**SOLICITATION AMENDMENT
MODIFICATION DE L'INVITATION**

Title - Sujet Asphalt Parking Lot Additions	
Solicitation No. - N° de l'invitation F1737-171004/A	Amendment No. - N° modif. 003
Client Reference No. - N° de référence du client F1737-171004	Date 2018-01-05
GETS Reference No. - N° de référence de SEAG PW-\$PWY-036-8261	
File No. - N° de dossier PWY-7-40276 (036)	CCC No./N° CCC - FMS No./N° VME
Solicitation Closes - L'invitation prend fin at - à 02:00 PM on - le 2018-01-12	
Time Zone Fuseau horaire Pacific Standard Time PST	
F.O.B. - F.A.B. Plant-Usine: <input type="checkbox"/> Destination: <input checked="" type="checkbox"/> Other-Autre: <input type="checkbox"/>	
Address Enquiries to: - Adresser toutes questions à: Martin (PWY), Delia	Buyer Id - Id de l'acheteur pwy036
Telephone No. - N° de téléphone (778) 707-2139 ()	FAX No. - N° de FAX (604) 775-6633
Destination - of Goods, Services, and Construction: Destination - des biens, services et construction: DFO - Institute of Ocean Sciences - Sidney, BC

This Amendment #003 is raised to issue the following changes:

The following changes in the tender documents are effective immediately. This Addendum will form part of the contrac

PARKING LOTS
A, B AND F
GRADING PLAN

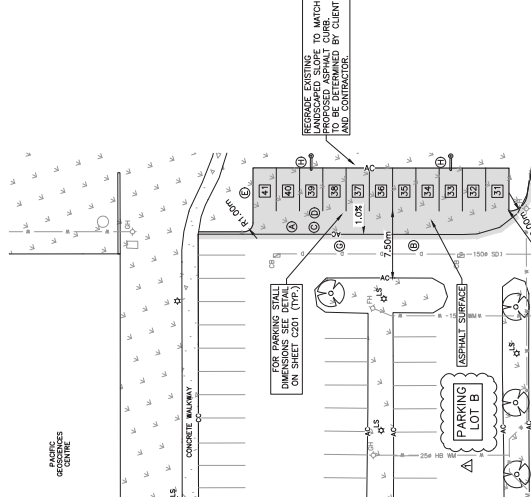
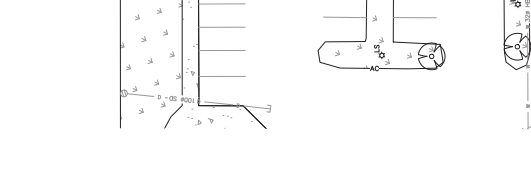
TREE ROOTS IN ASPHALT AND
PE AREAS TO BE REMOVED.
EXISTING LANDSCAPED SLOPE TO
PROPOSED ASPHALT CURB. EXTENT TO
BE DETERMINED BY CLIENT AND CONTRACTOR.
